Jacobsen Information Bulletin

Product Type: Lawnaire IV & V

Bulletin No: C-019-05

Drive Belt Disengagement

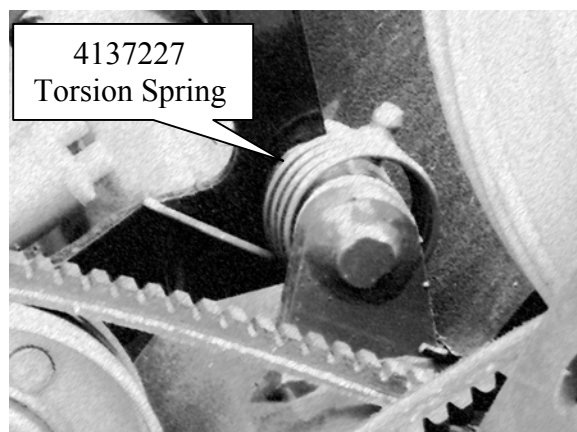
ISSUE:

In order to enhance our product, a torsion spring has been released to add additional disengagement of the drive wheel.

Install torsion spring part number **4137227** as shown.
